Access Compliance Report Public Rights-of-Way (Curb Ramps)

Main Street: NEWBURY_RD Cross Street: INVERNESS_DR Location: NE

ADA ID: RPRK211216134816 Ramp Type: Type 1 - Perpendicular Diagonal Initial Pass/Fail: Pass Overall Compliance: No Severity Score: 6

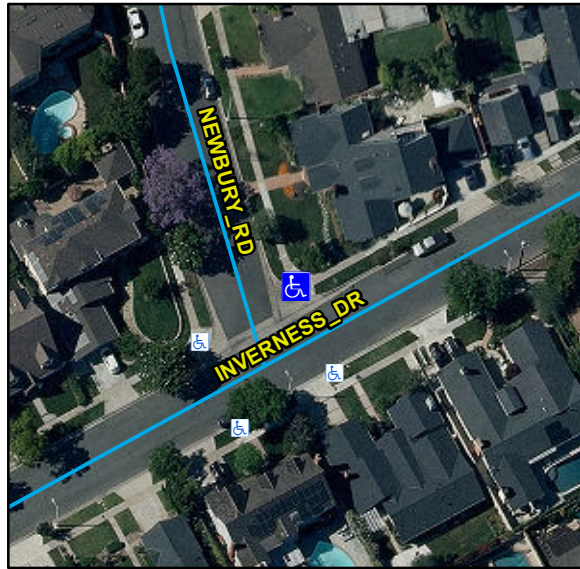
Remove & Replace Landing.
